## **DCUSA Issues Form (DIF)**

<b>Document Control</b>	
Date Submitted	29 May 2015
Issue Title:	National Terms Of Connection – Section 3 Power Factor clause defect
Issue Number*:	49
Meeting Ref*:	26 June 2015
Attachments:

Figure 23 Historic Q/P Ratio Trend

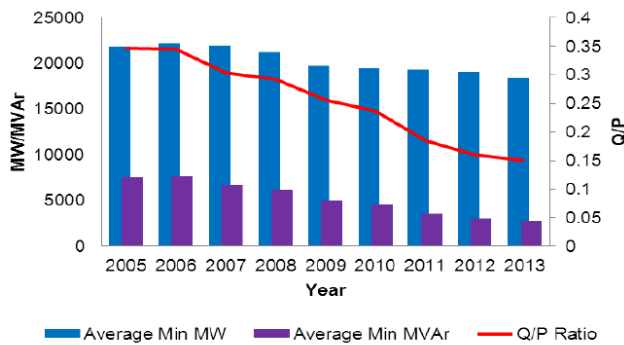
The reduction in distribution system Reactive Energy Import alters the reactive energy balance in the regional transmission system and causes generation equipment, generally transmission connected generation, in the region to have to operate at a different active/reactive energy operating point and this risks causing such generation to be less stable and be more susceptible to over-voltage wear and tear or damage. Factors stated by National Grid in the SOF, impacting on transmission system assets as well as connected generation, are Flashover risks, Asset overstressing and insulation breakdown, Wound equipment over-fluxing, Risk of circuit breaker re-strike during de-energisation, Increased risk of asset catastrophic failure.
